ADDENDUM NO. 1

Wayne High School Campus Improvements

Fort Wayne Community Schools (FWCS)

November 7, 2025

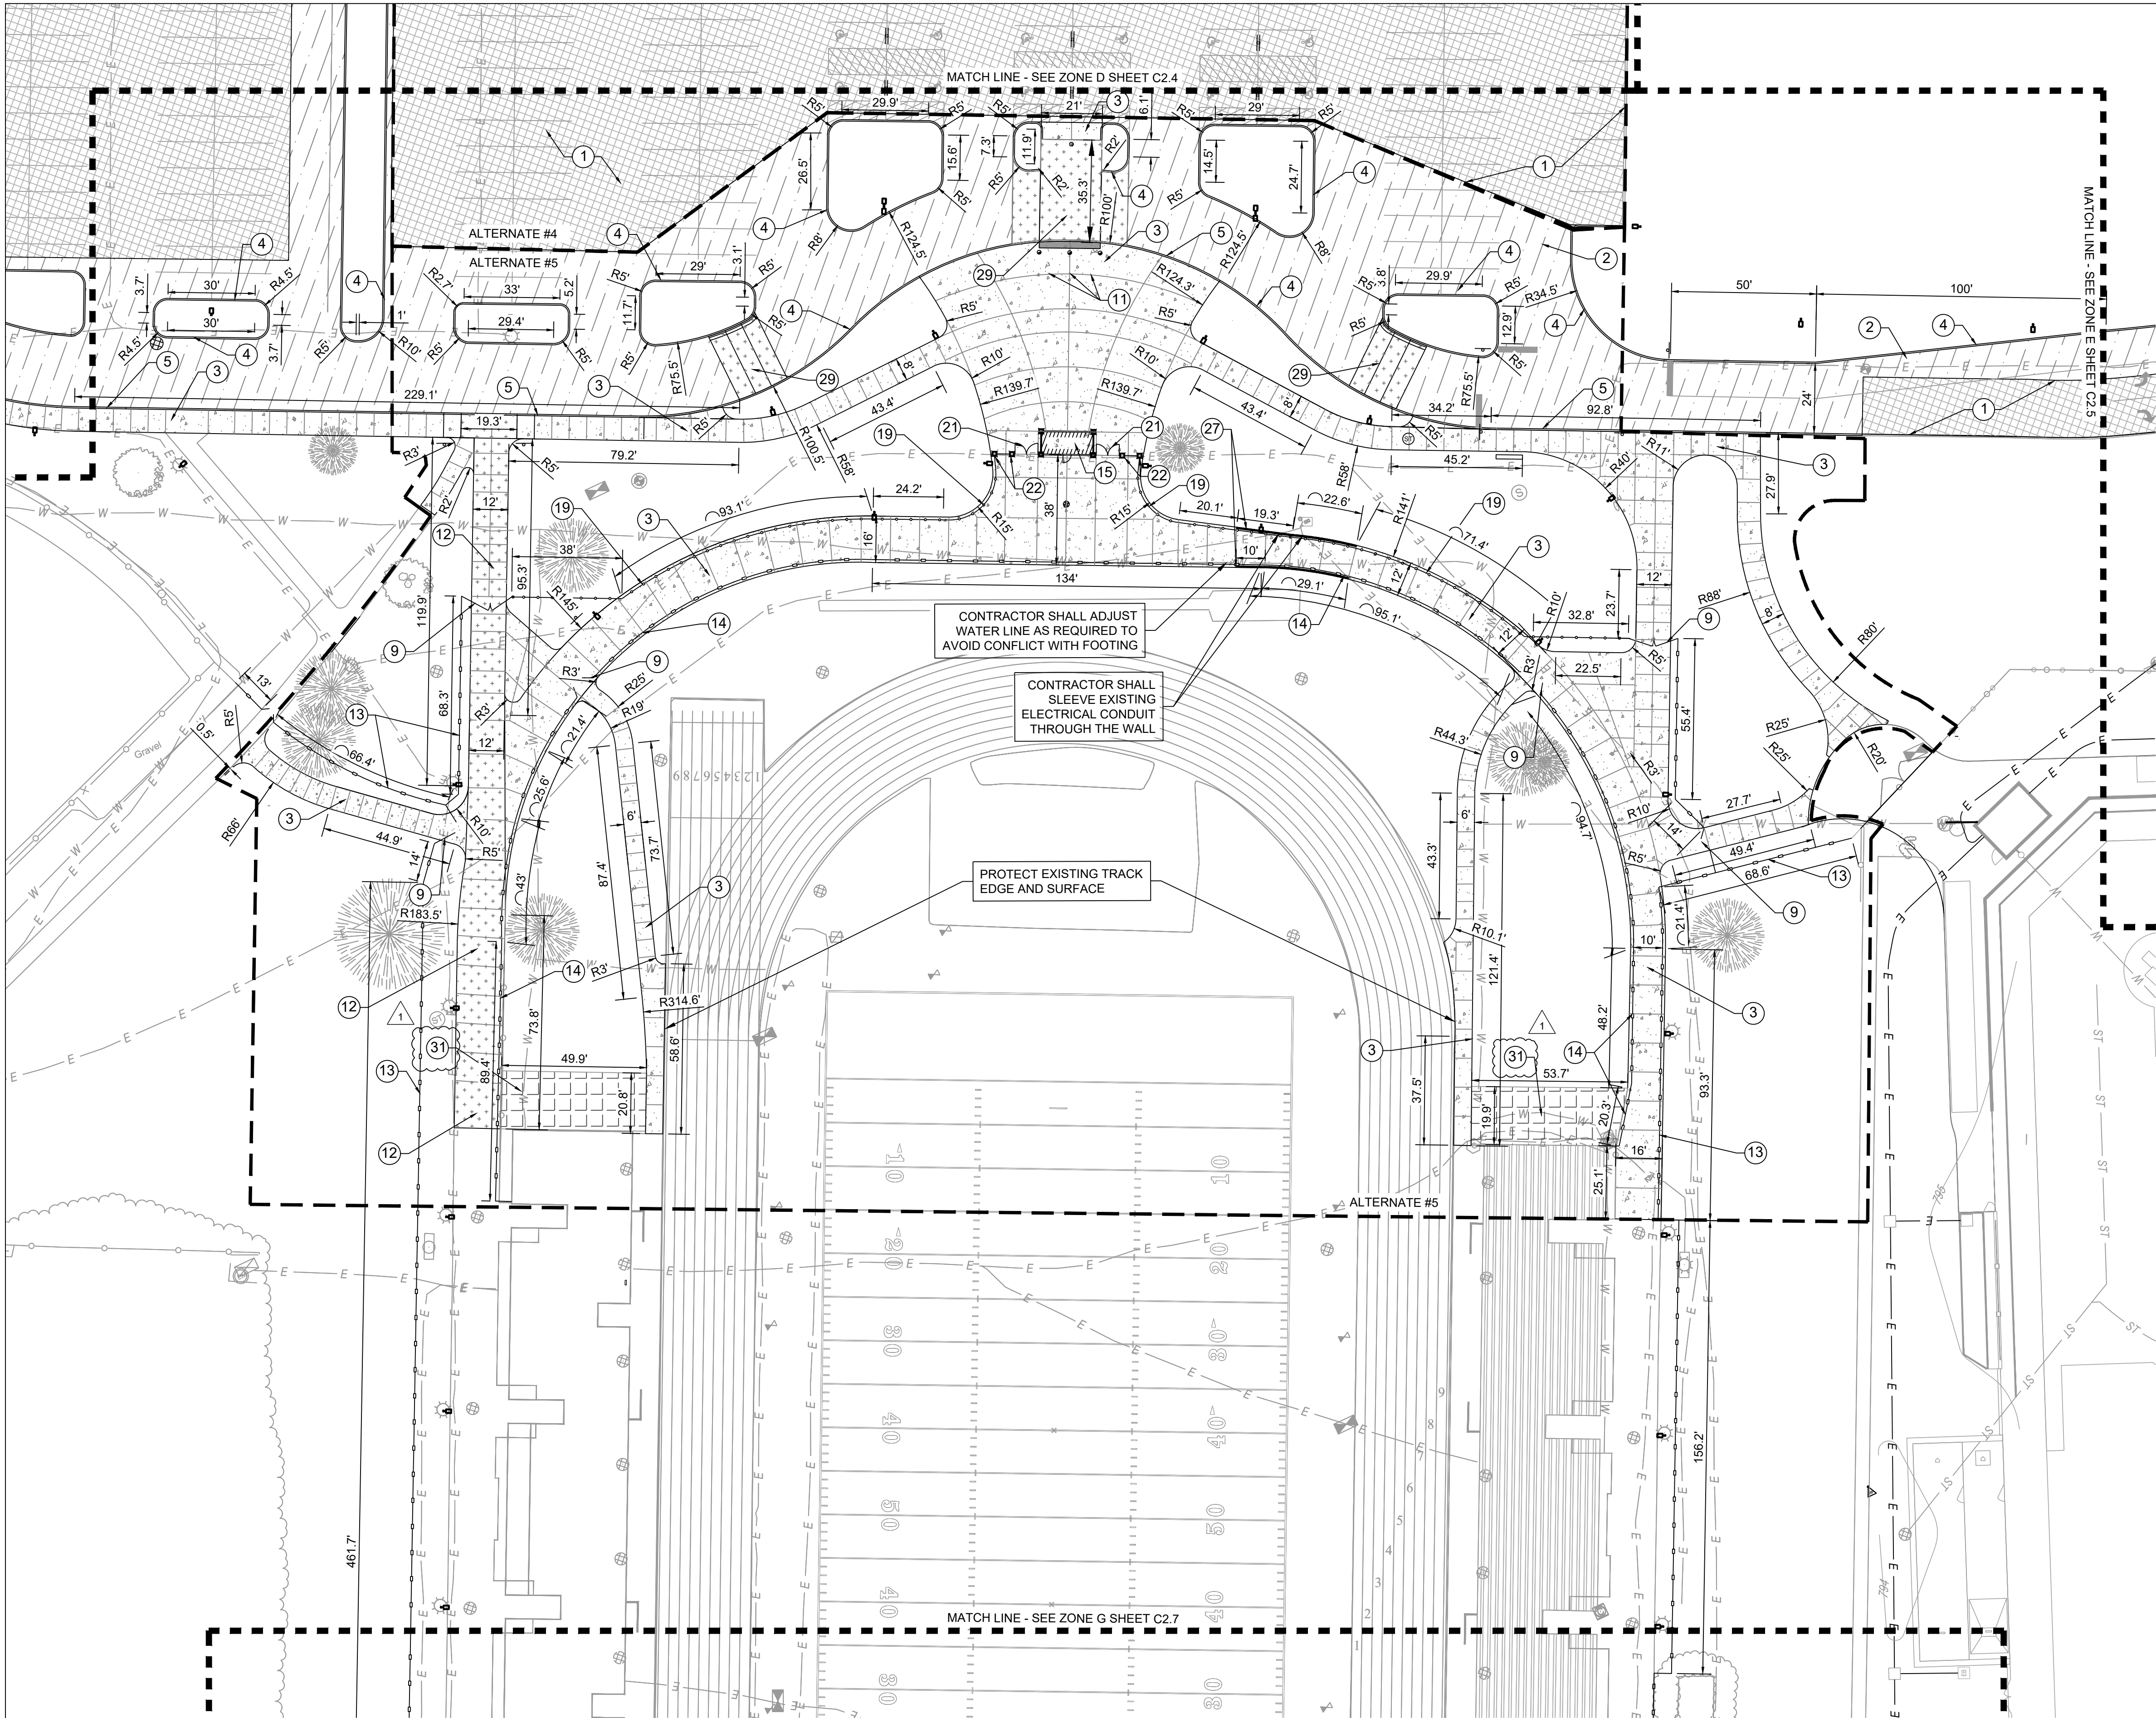
REVISED: Keynote 20 – Erosion Control Surface Flexamat or Approved Equal on Detail Legend to corrected detail (3/C5.3).

ADDED: Erosion Control Turf Reinforcement to Detail Legend.

REVISED: Keynote 20 on plans to Keynote 31.

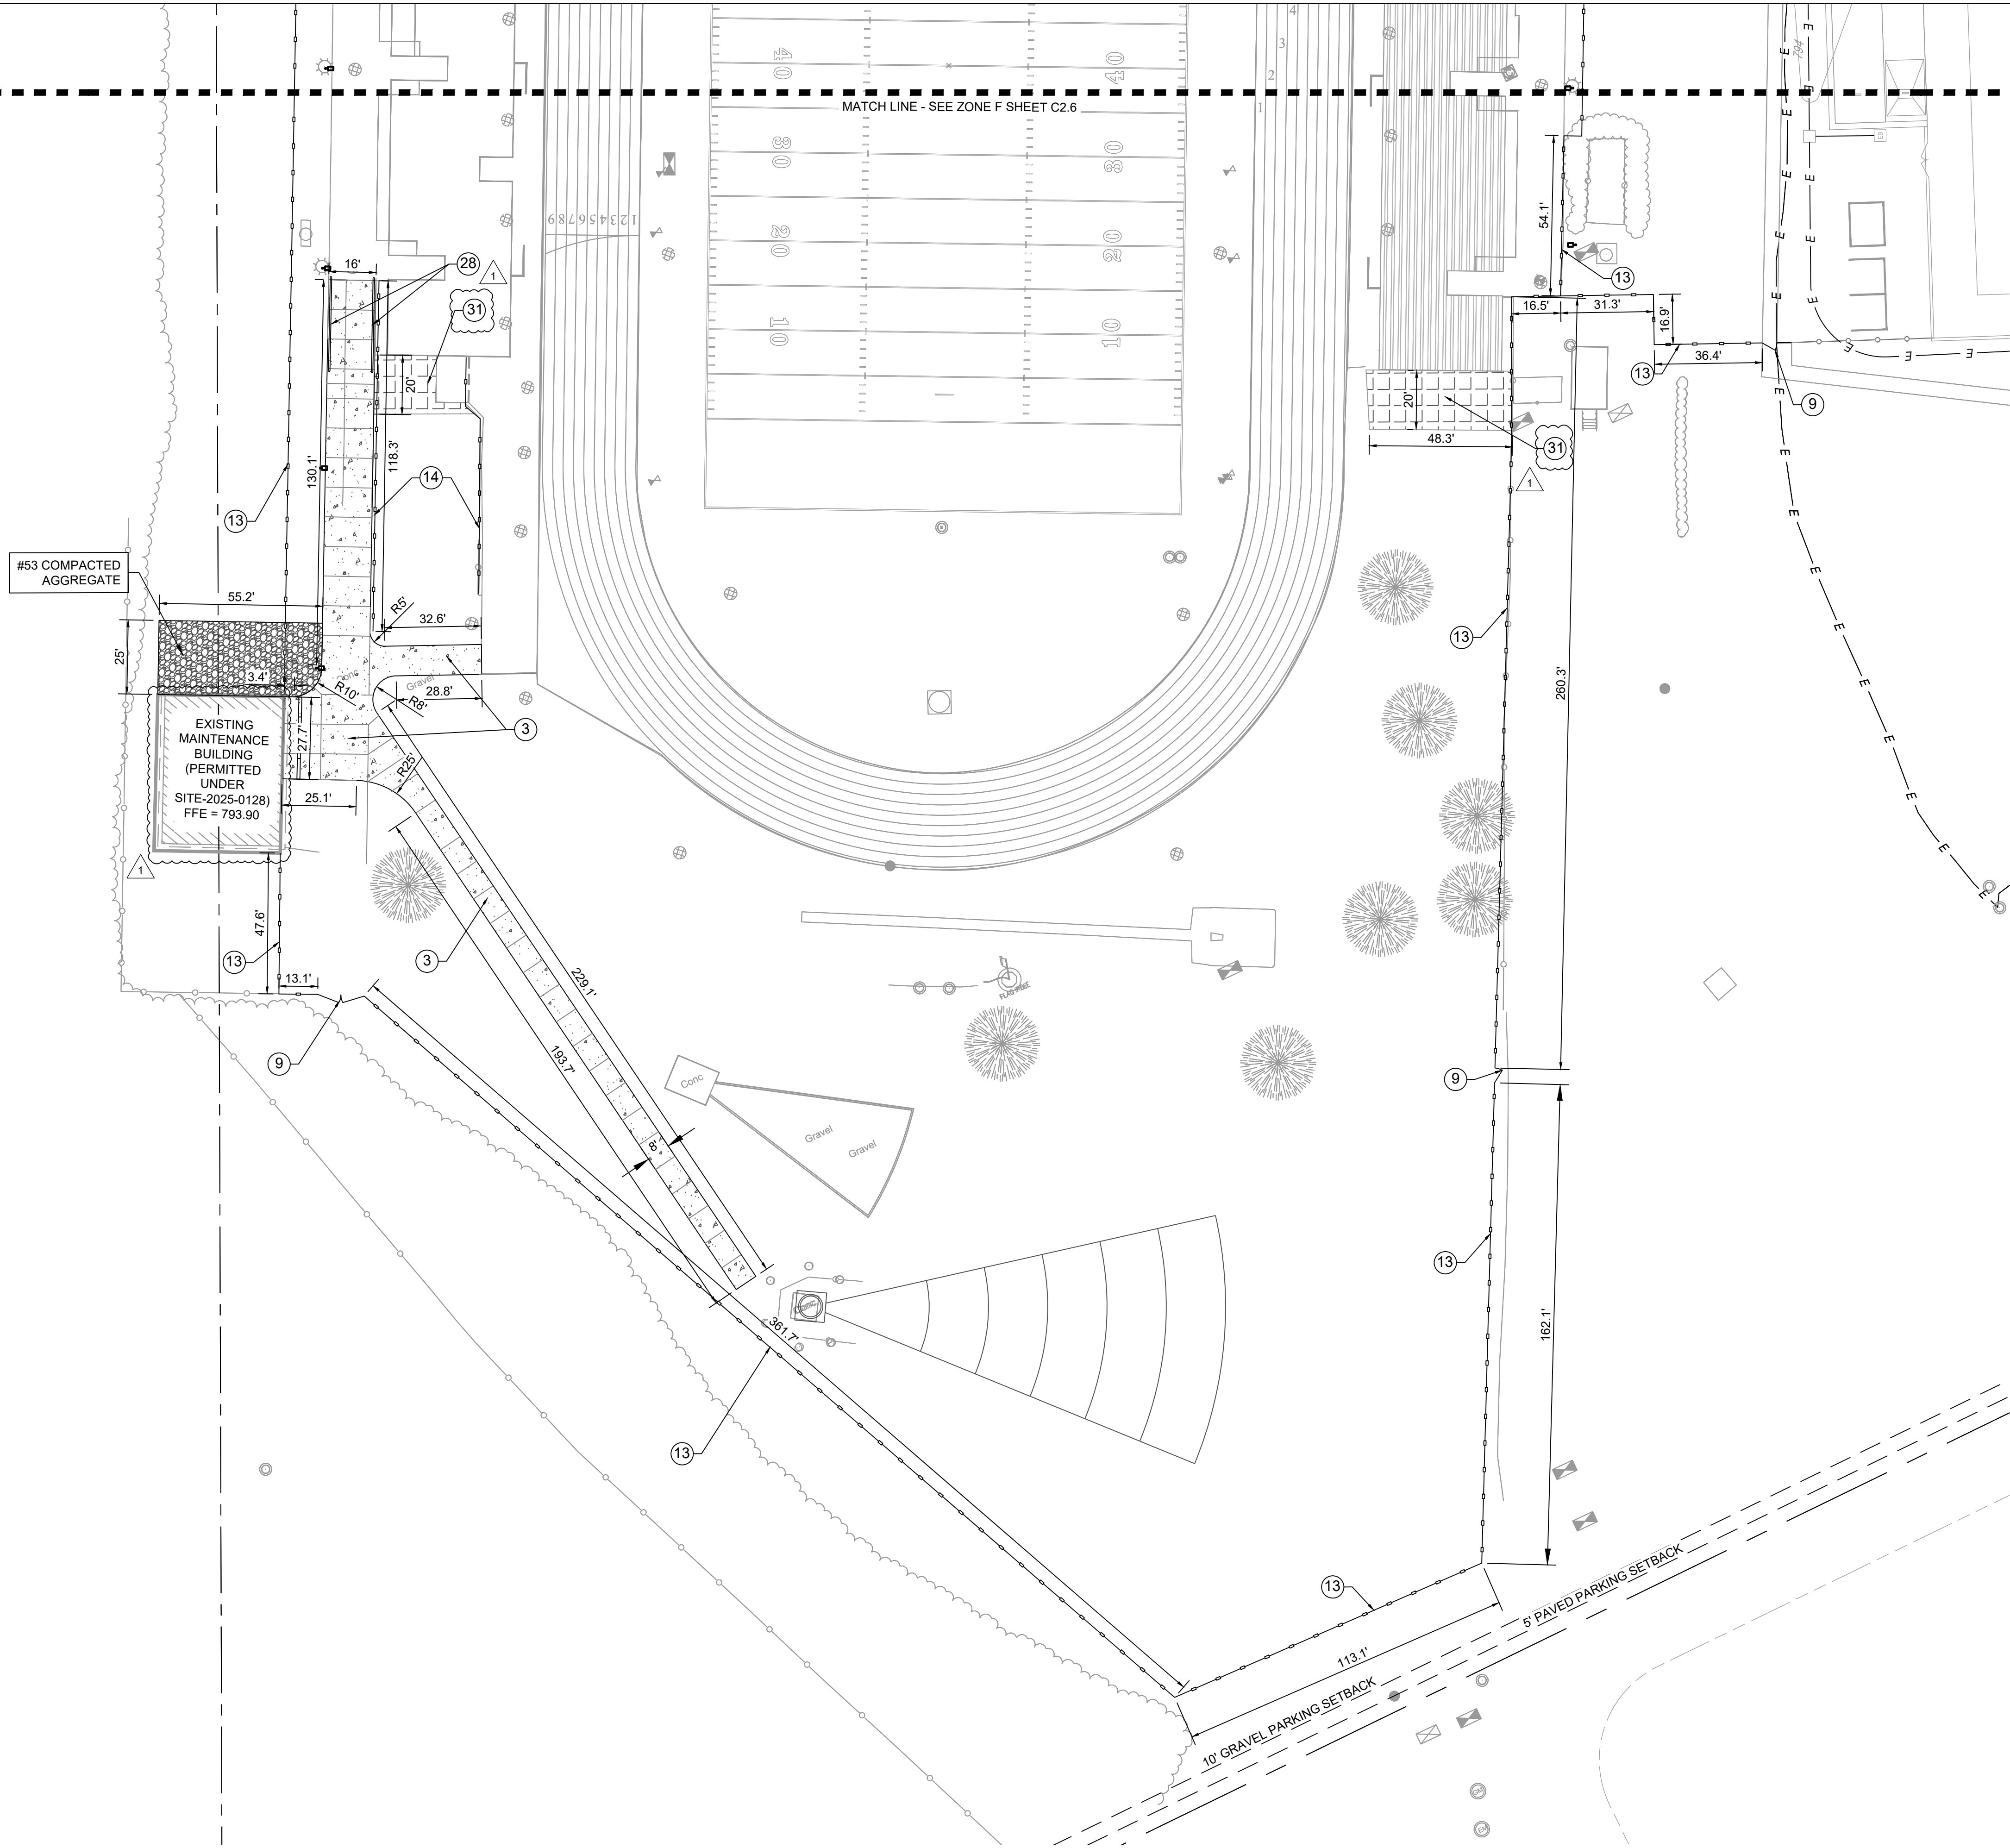
REVISED: Keynote 20 – Erosion Control Surface Flexamat or Approved Equal on Detail Legend to corrected detail (3/C5.3).

ADDED: Erosion Control Turf Reinforcement to Detail Legend.

REVISED: Keynote 20 on plans to Keynote 31.

REVISED: Maintenance Building description.

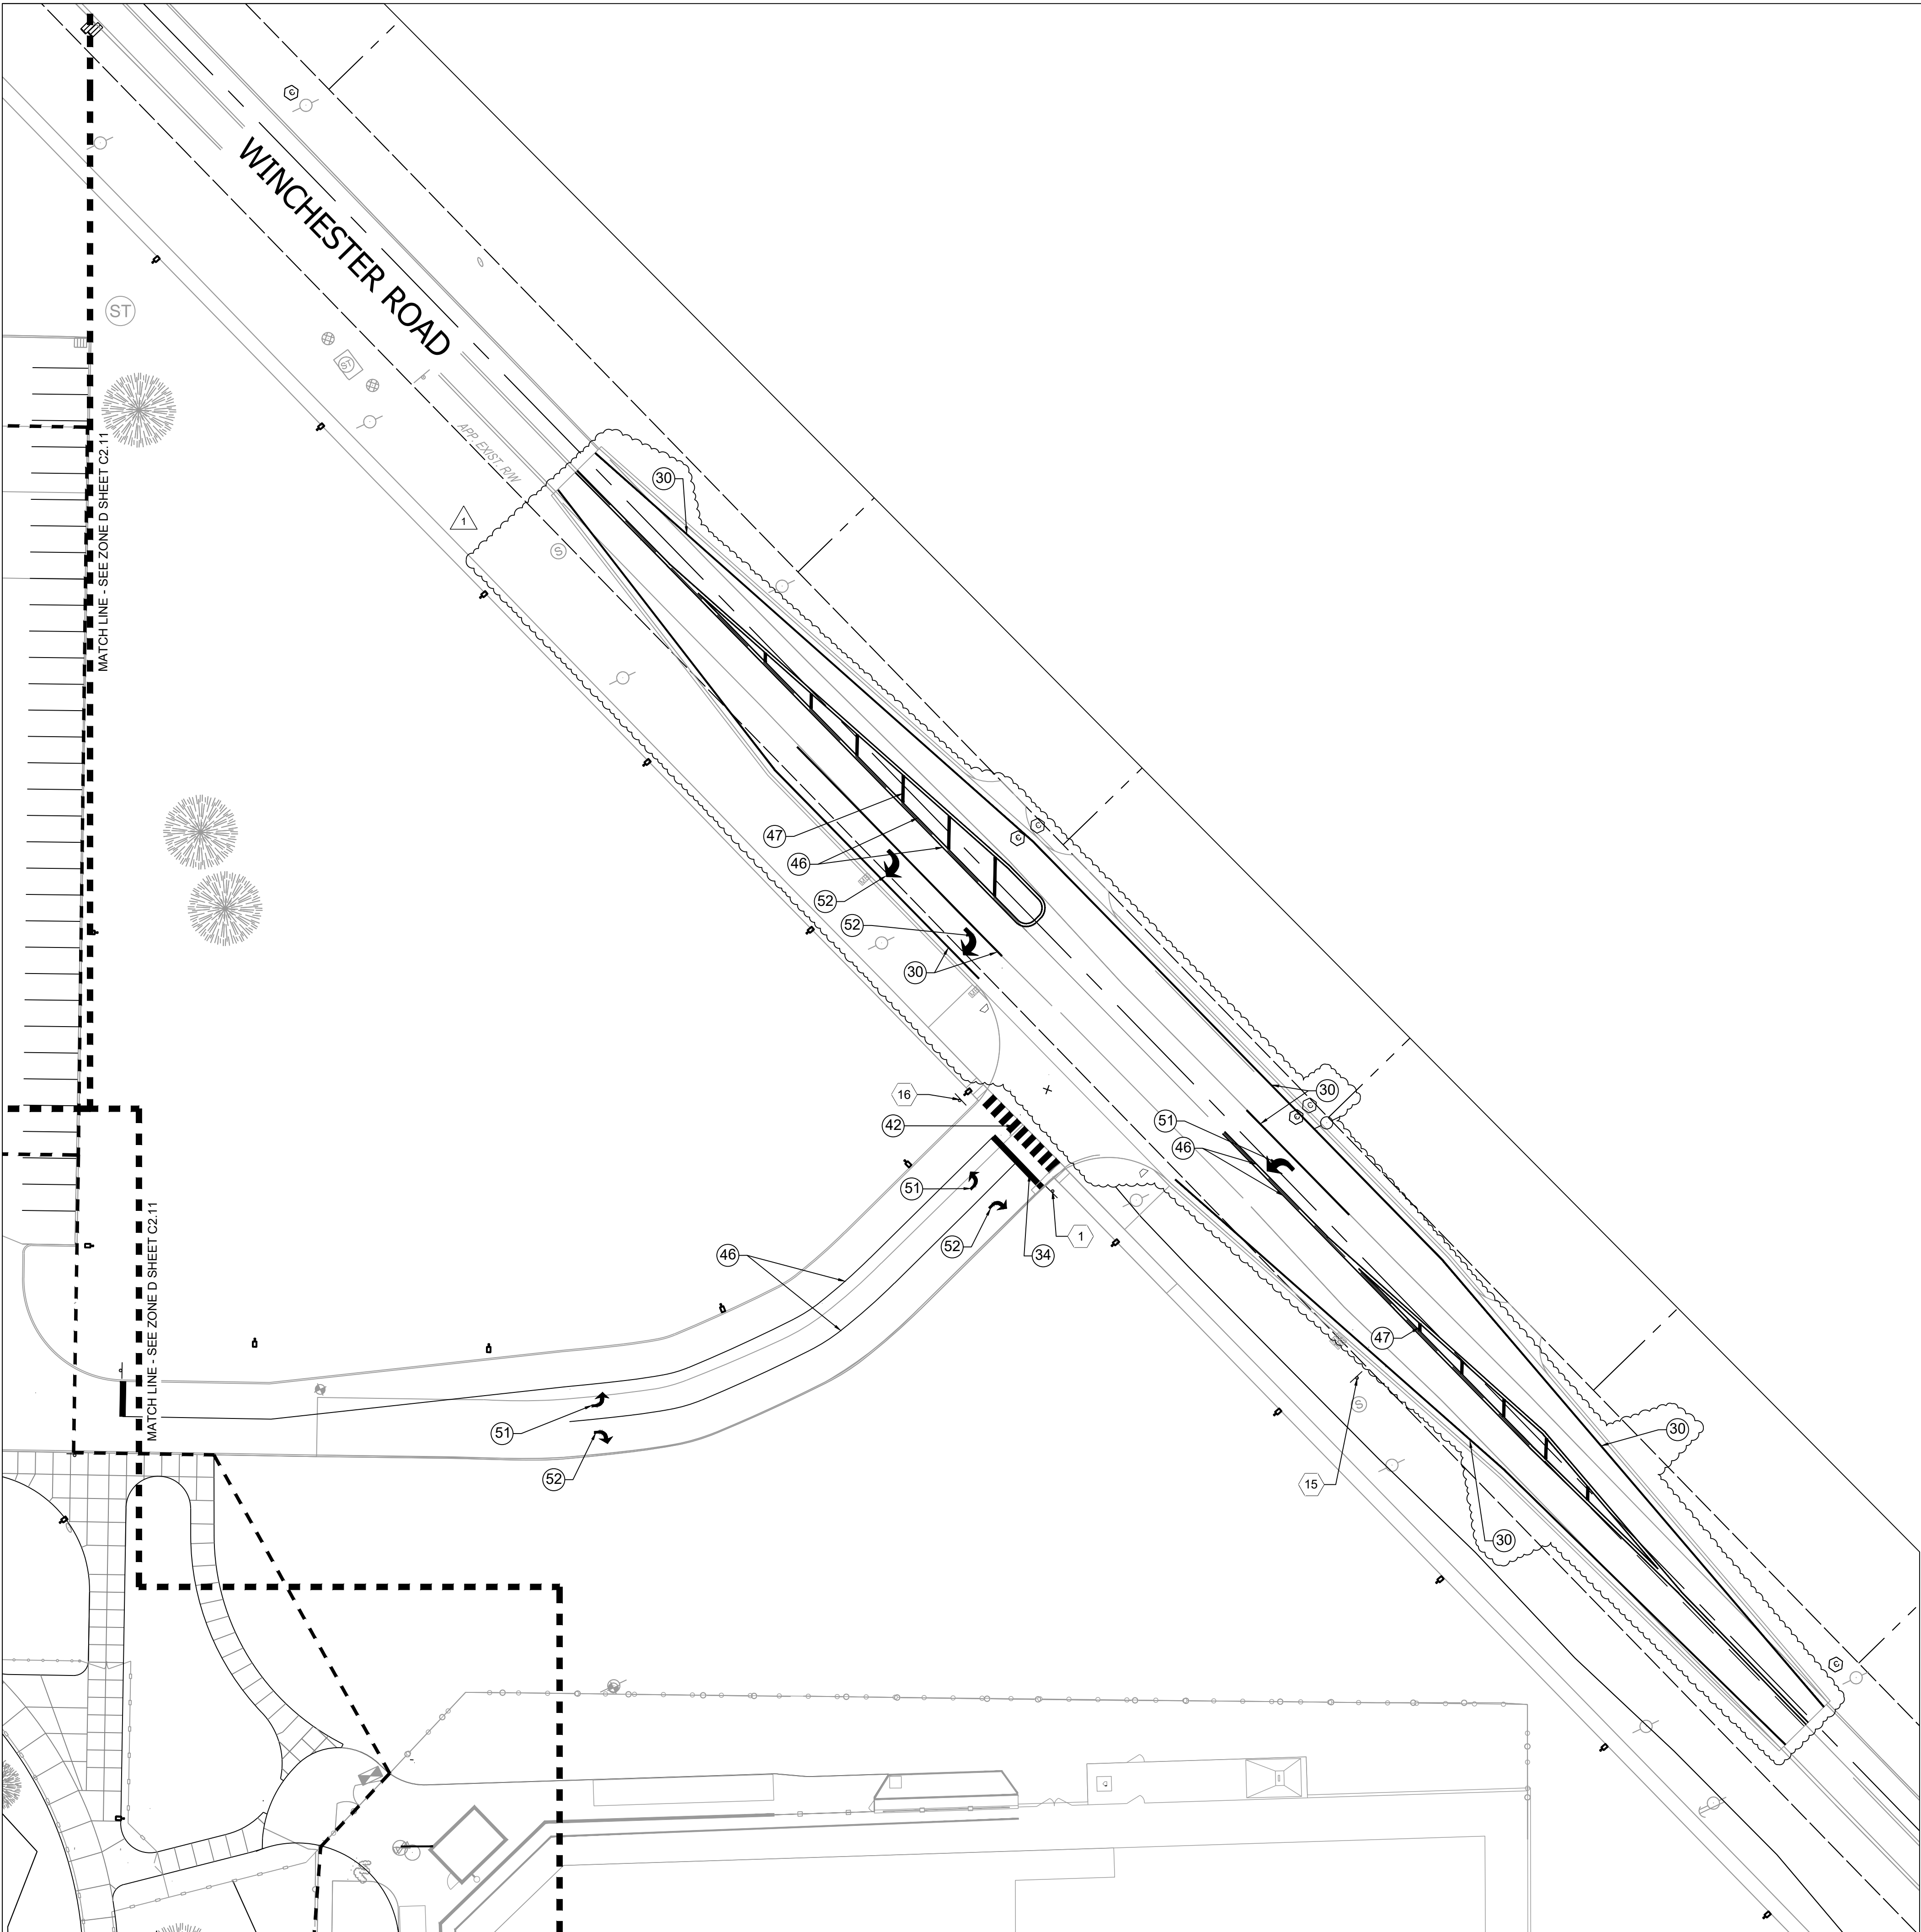
REVISED: Pavement markings on Winchester Road turn lanes.
